## ADDENDUM NO. 2

**Date:** August 26, 2021  
**Project Name:** Airfield Marking Rehabilitation for the Jack Brooks Regional Airport  
**Owner:** Jefferson County, Texas  
**Owner Project No.:** IFB 21-052/JW  
**Garver Project No.** 20A12502

RUNWAY 16-34  
 MARKING REMOVAL  
 PLAN II

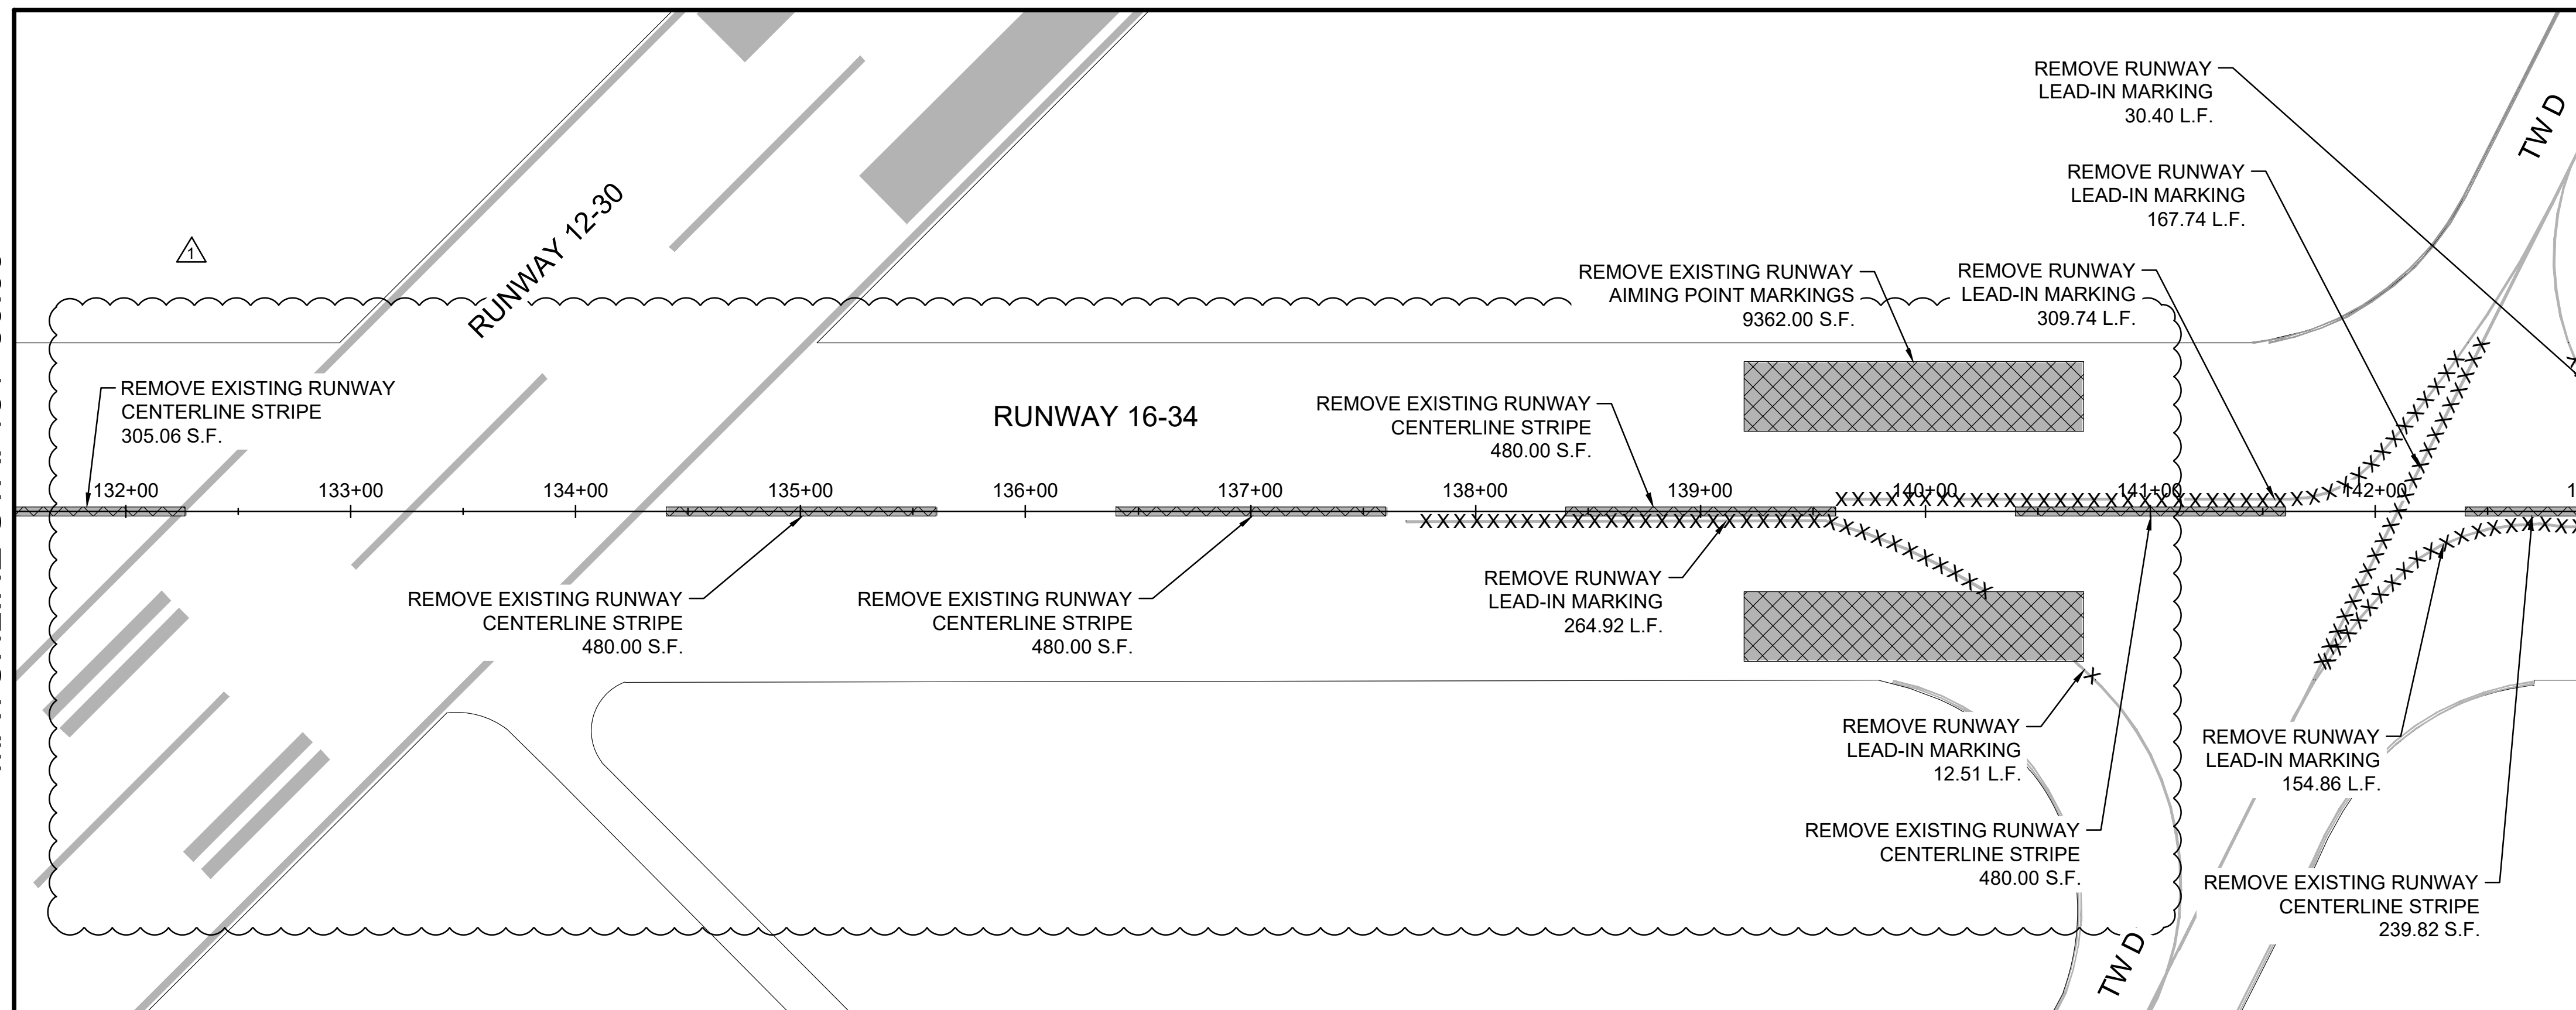
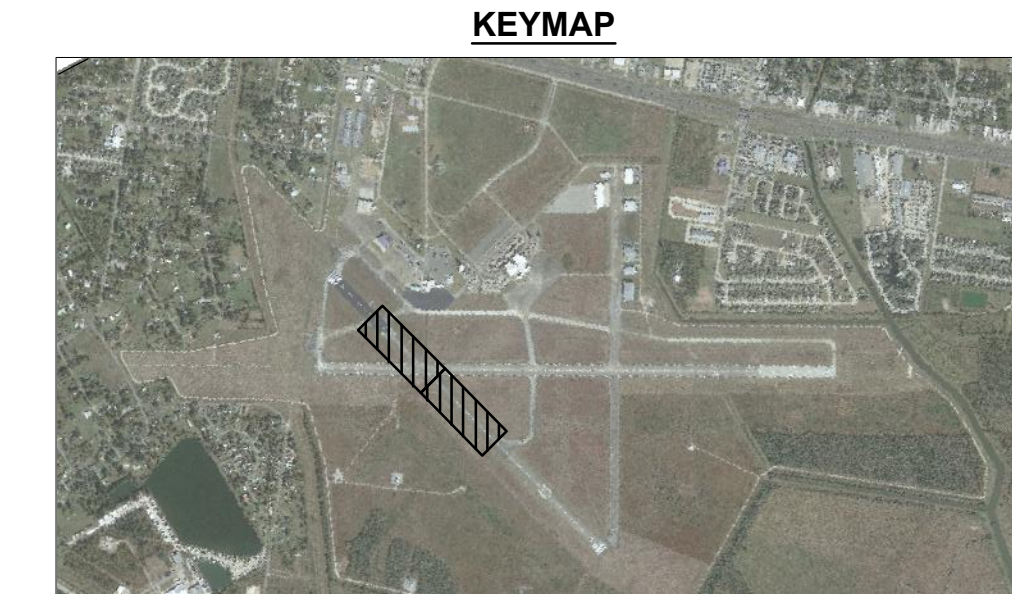
- f. According to Google Earth, the runway centerlines are 120 ft by 3ft for the white. On the plan sheets it says 120 ft by 18". What are the current centerlines measured at?

- g. How did you determine the square feet measurement of 433.55 on the centerlines? What measurements did you use?
  - i. The removal quantity for the existing runway centerline markings has been corrected (see section B below) to 480 SF in this addendum. This accounts for the 120 ft by 3 ft of white markings with the 0.5 ft black outline.

- h. How did you determine the square feet measurement of 9359.52 on the aiming point? What measurements did you use?
  - i. The removal quantity for the existing aiming point markings has been corrected (see section B below) to 9362 SF in this addendum. This accounts for the 150 ft by 31 ft of white markings with the 0.5 ft black outline for the pair of markings.

- i. The existing runway centerlines are 120 ft by 3 ft. The proposed runway centerlines will be 120 ft by 1.5 ft white paint with 0.5 ft black outline. The removal quantity for the existing markings has been updated (see section B below) in this addendum.
